Product Change Notice

PCN #: BE131224

Re: Label Change

All VI(VE)-200 Drivers and Boosters, VI(VE)-HAMs, VI(VE)-BAMs, VI(VE)-HAMD, VI(VE)BAMD, VI(VE) BatMods, and VI(VE)-J00.

Figure 4 – Old label

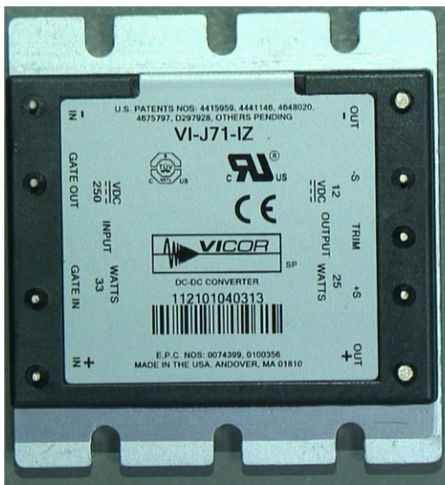
The belly label of the modules will change in two steps. The first change is to remove the model number barcode and center the model number. The second change is to left justify the model number. See figures 1-3 for images of the old, interim and final labels.
